**TOWN OF BAY HARBOR ISLANDS
DEVELOPMENT & REVIEW COMMITTEE MEETING
THURSDAY, OCTOBER 13, 2022**

**TOWN OF BAY HARBOR ISLANDS
COMMUNITY DEVELOPMENT
MEMORANDUM**

Subject: Site Development Plan Application – DRC Review #2
Proposed New Multiple-Family Development (44 DU)
Existing Bay Harbor Tower Site (30 DU)
10141-10143 East Bay Harbor Drive
Bay Harbor Islands Acct. No. SPR22-000024
MMPA Acct. No. 01-0702-1142

Date	09-29-2022	Sheet No.
Scale		A3.00
Project	0000

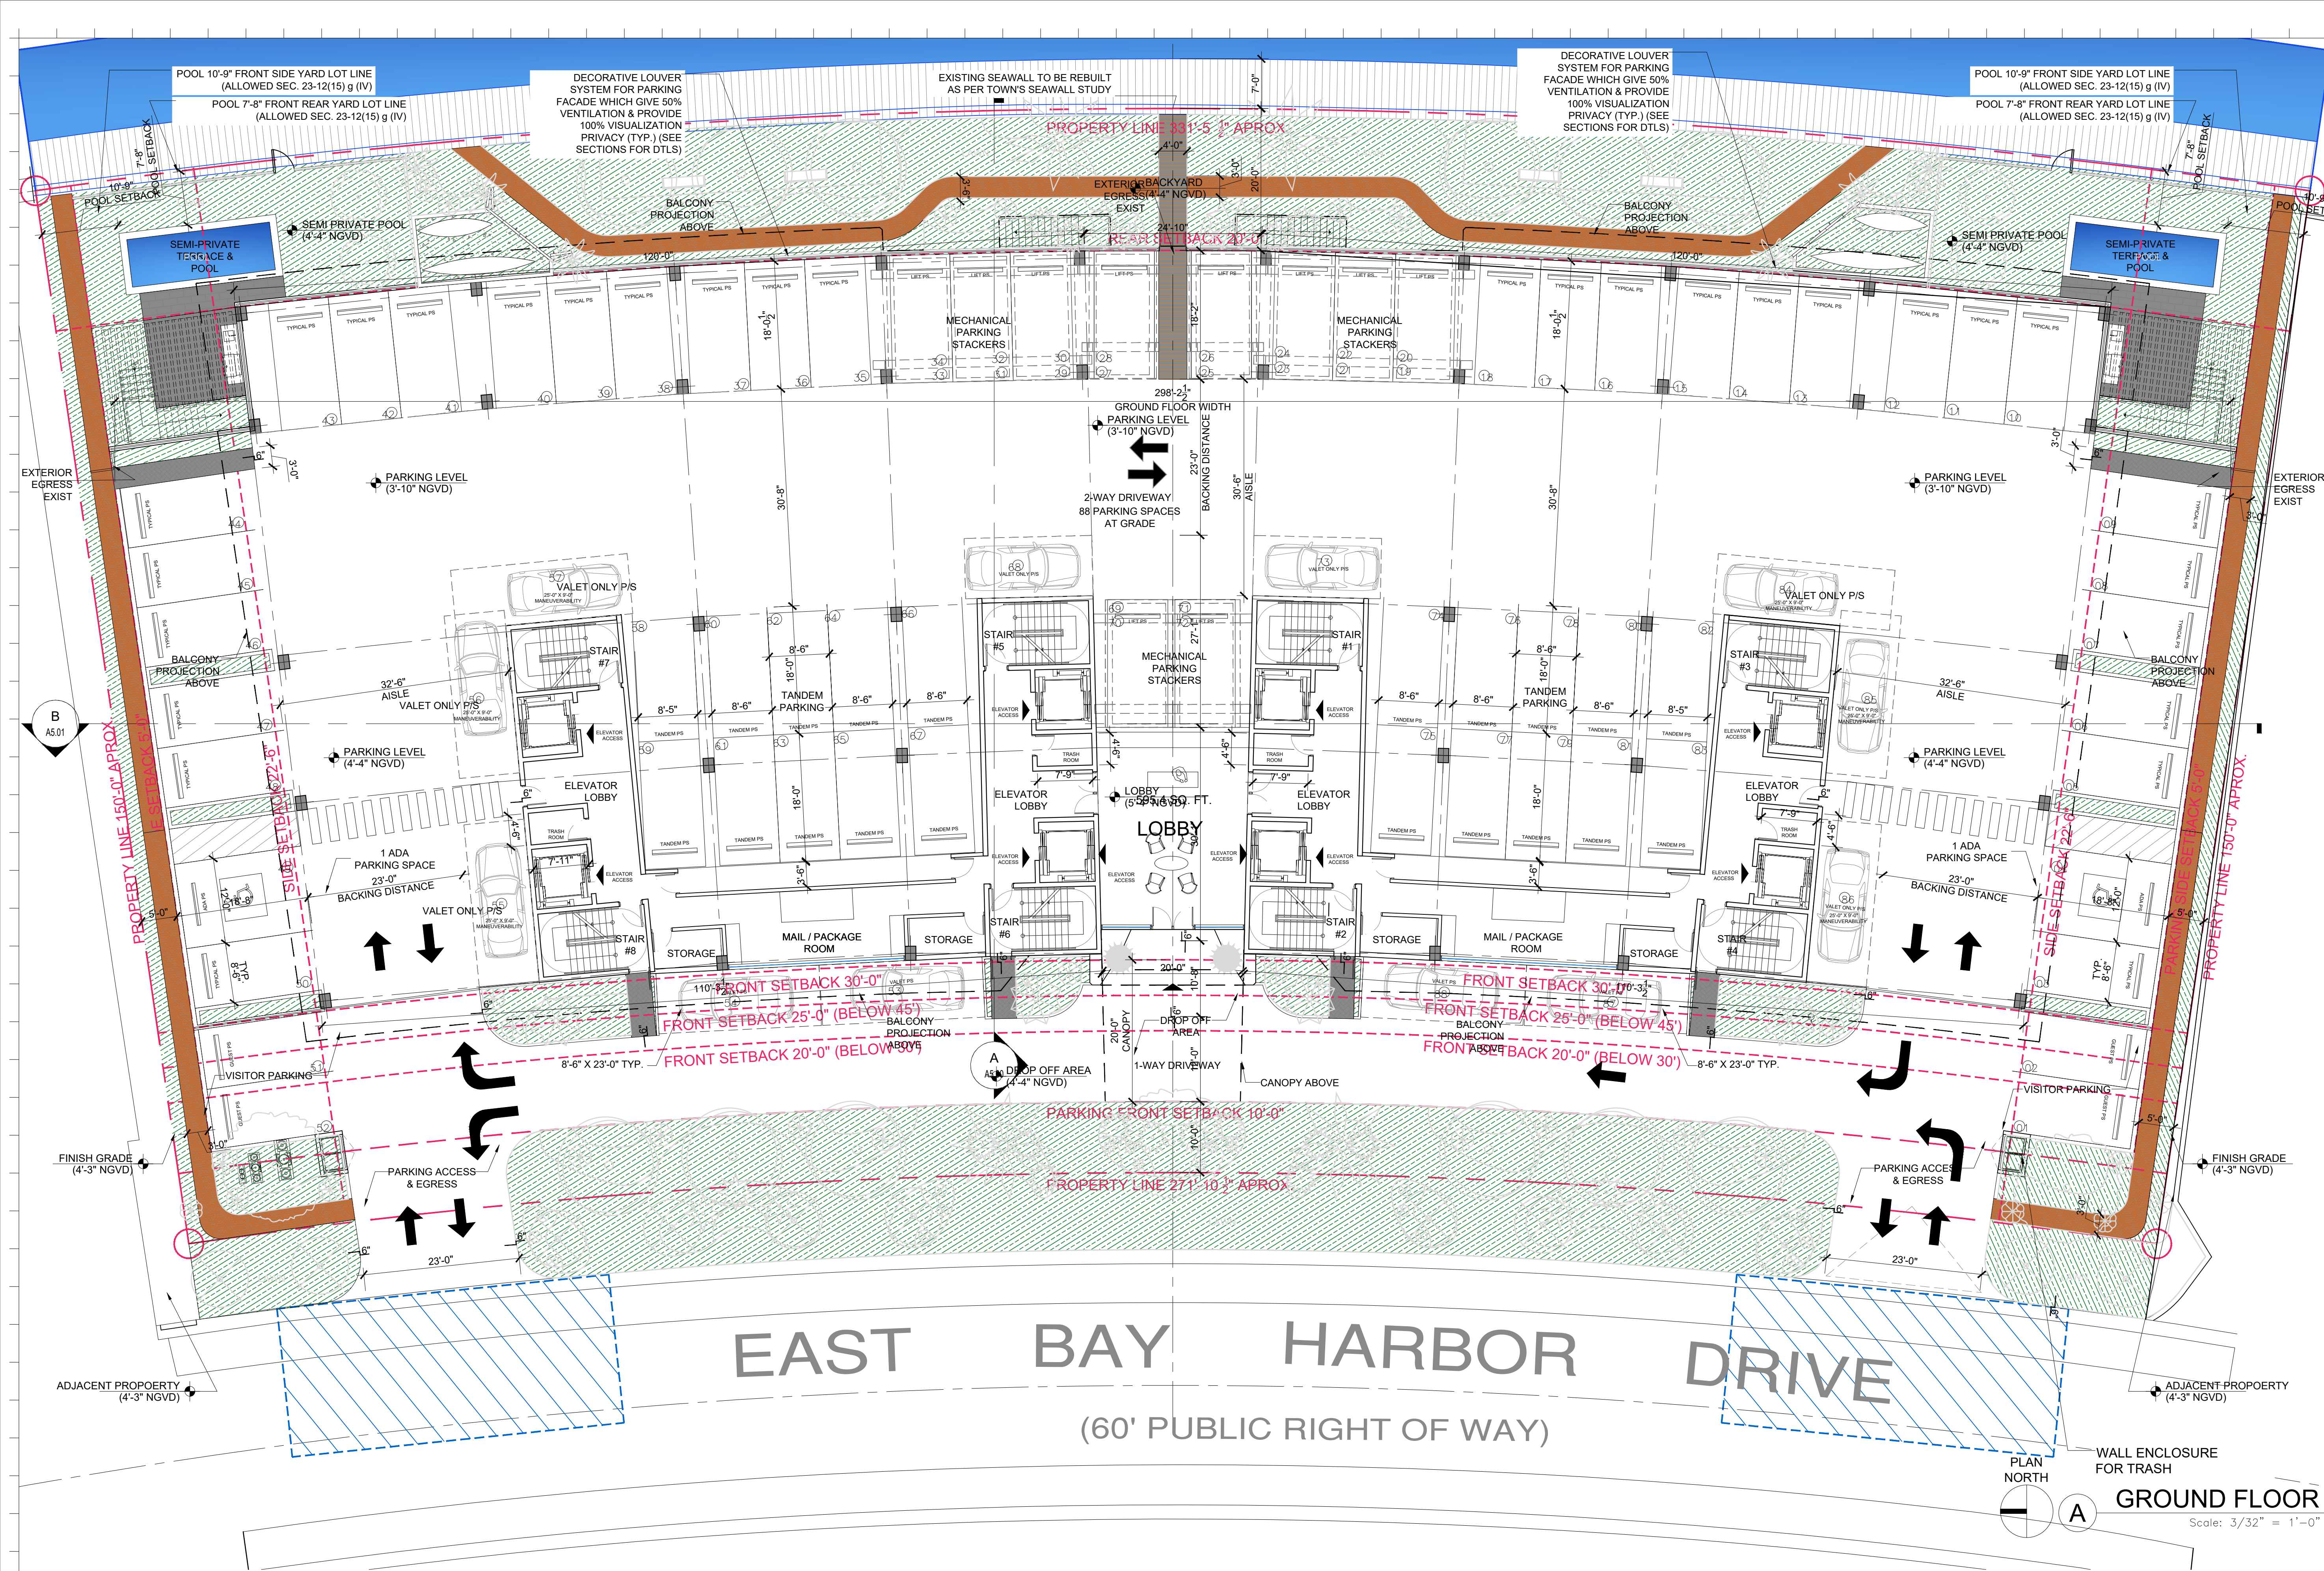
3. On Sheet A2.00 and Sheet A3.00 there are errors with the rear yard swimming pool locations and referenced Code sections. For waterfront sites Sec. 23-12(15)(g)(i) applies – not subsection (iv) as that applies to non-waterfront lots. Pools / pool decks can be located not less than 5' to the rear PL / seawall – the plans show 7'-8" for some reason. You can leave them as shown or relocate them. However, Sec. 23-12(15)(g)(i) prohibits pools from being placed in the minimum side setbacks – the plans show the 2 semi-private pools partially within the min. 22.5' side setbacks. Please revise the plans accordingly.

4. On Sheet A2.00 / Sheet A3.00 / others there are setback violations shown for the proposed 3' wide walkways along the side lot lines. Per Sec. 23-12(15)(b) no such walkway may be placed closer than 3' to a side lot line, as this area is needed for drainage and buffering. The plans provide no setback dimension but a 5' setback from the parking spaces is shown with a 3' width shown for the walkway leaving only 2'. Also, a physical barrier to screen the parking areas from the adjoining sites are required per Sec. 24-16. Please revise the plans accordingly.

5. On Sheet A2.00 / Sheet A3.00 / others there appears to be some type of private terraces near the semi-private swimming pools at grade level. Not enough detail is provided to determine Code compliance as to setbacks / materials / roof coverings / height / etc. The elevations seem to show a roofed structure – so setbacks are required. Please revise the plans accordingly. See Sec. 23-12(15)(e)(iii) for Code allowances.

L-1.2

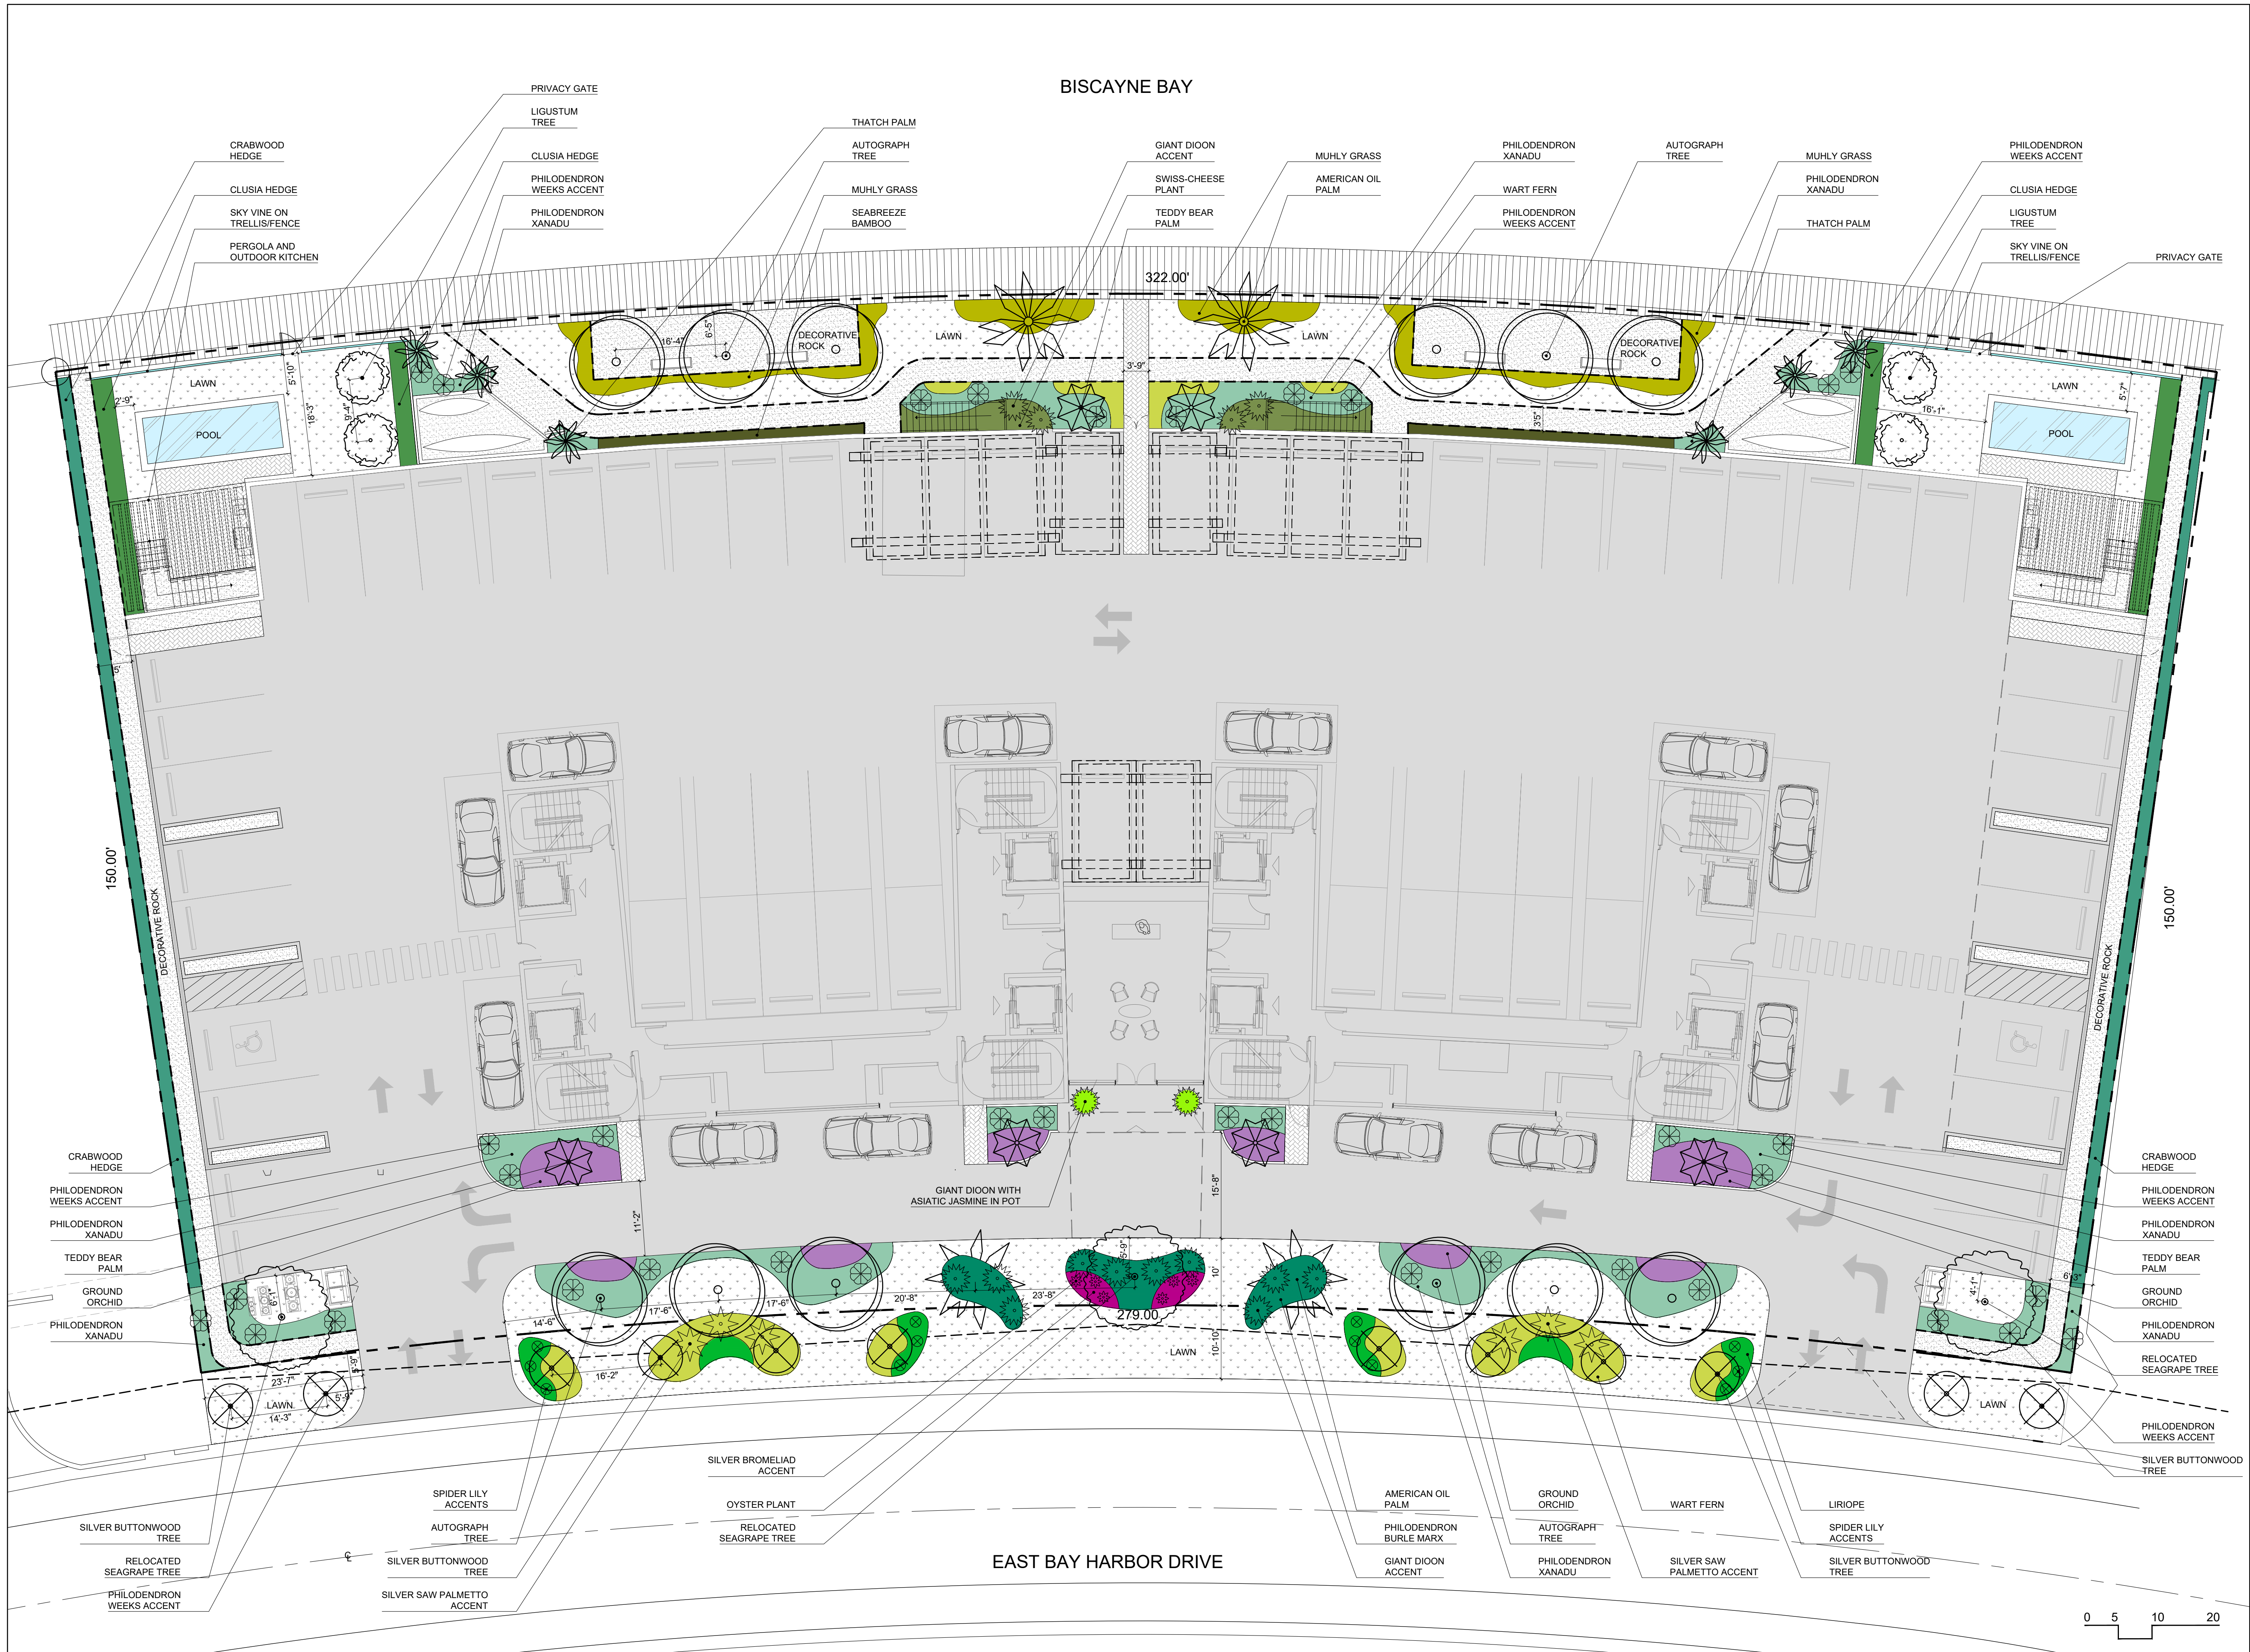
2) On Sheets A1.01, A2.00, A3.01, the Civil Engineering Plans and Landscape Plans the applicable Landscape Codes (M-D / Town) requires a minimum 10' landscape strip along roadways separating driveways & parking spaces from the front property line, but the Town Code allows the DRB to consider somewhat narrower dimensions based on need (7' min. per M-D Landscape Code) upon request – not automatic approval. The center landscape strip is shown at 1'-6" – but no dimensions are shown. Revise the plans to reduce the driveway width and increase the landscape strip to meet minimum Code requirements. If a waiver is requested a written justification statement is required to be provided as to why the Code requirement cannot be met. The building footprint could be made smaller, or parking could be proved on the 2nd level as many others have done:

3) On Sheets A1.01, A2.00 and others the plans show grade level pools / pool decks and sitting area in the rear yard adjoining the waterway. Sec. 23-12(15)(e) requires a min. 5' landscape strip between the rear property line and any walkway / patio / pool / pool deck. This is required for compliance with the EPA NPDES drainage permit to pollutants can be retained on-site and not discharged into Biscayne Bay – a federally protected water body. Please revise the plans accordingly. Occasional perpendicular walkways from the upland areas to the seawall/docks are acceptable (5° width max.):

Landscape strip was revised to have 10' and dimensions were added, see sheet #L-2

Plans were revised accordingly to reflect 5' landscape material buffer, see sheet #L-2

Plans were revised accordingly to comply with code, see sheet #L-2

Date	08-24-2022	Sheet No.
Scale		PH-1.00
Project	0000

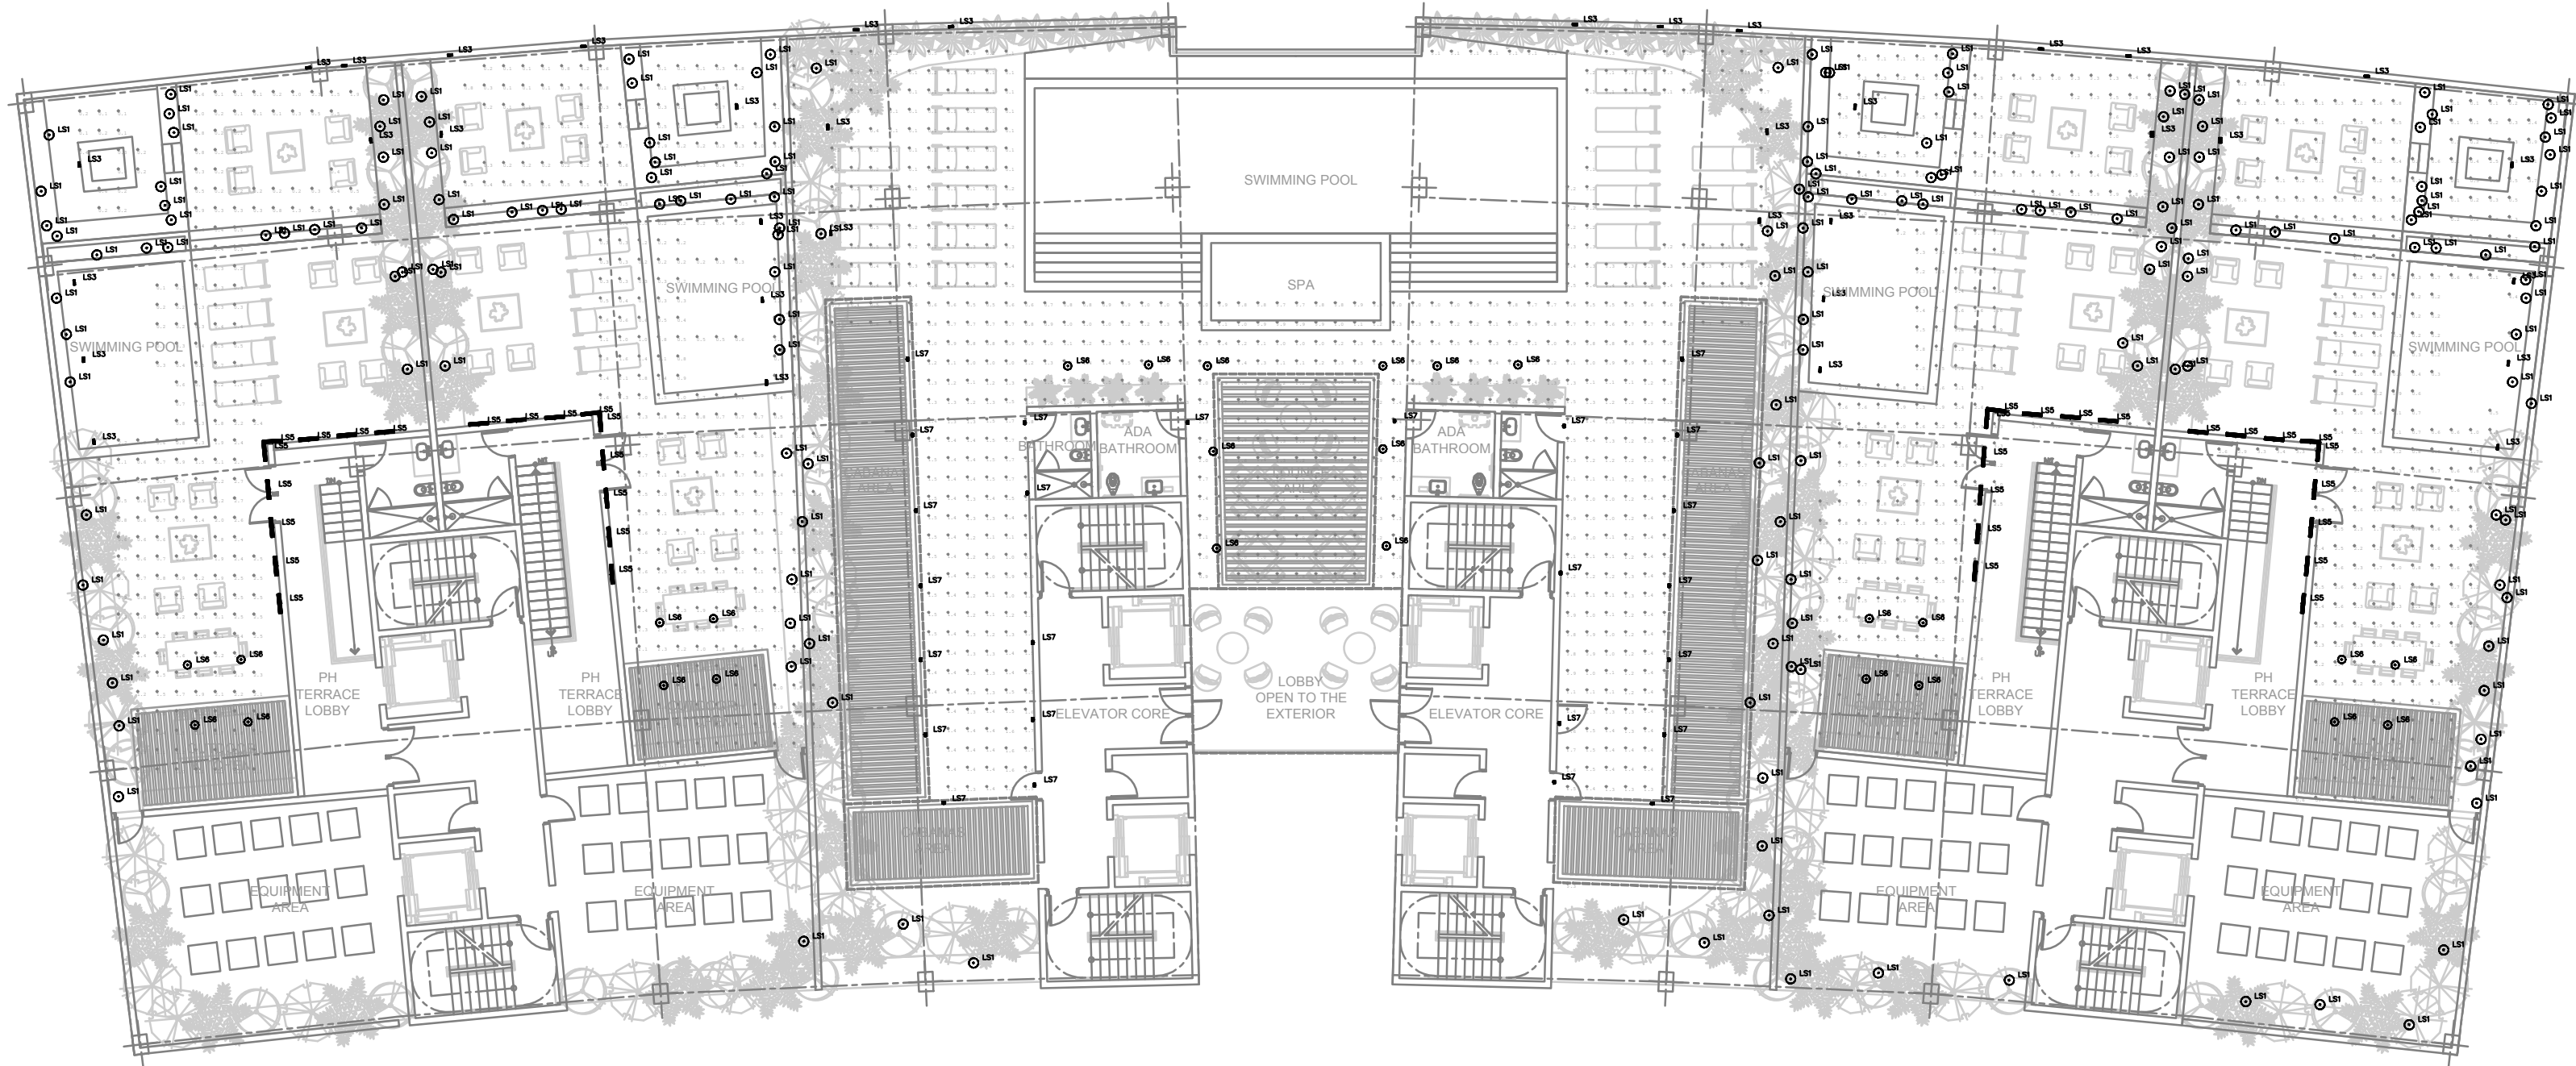
11. The revised preliminary Photometric Plans are not legible (print too small) to demonstrate compliance with Sec. 23-19 – there are footcandle readings for the yards / rooftop noted, but the print is too small to read. Please revise the plans accordingly.
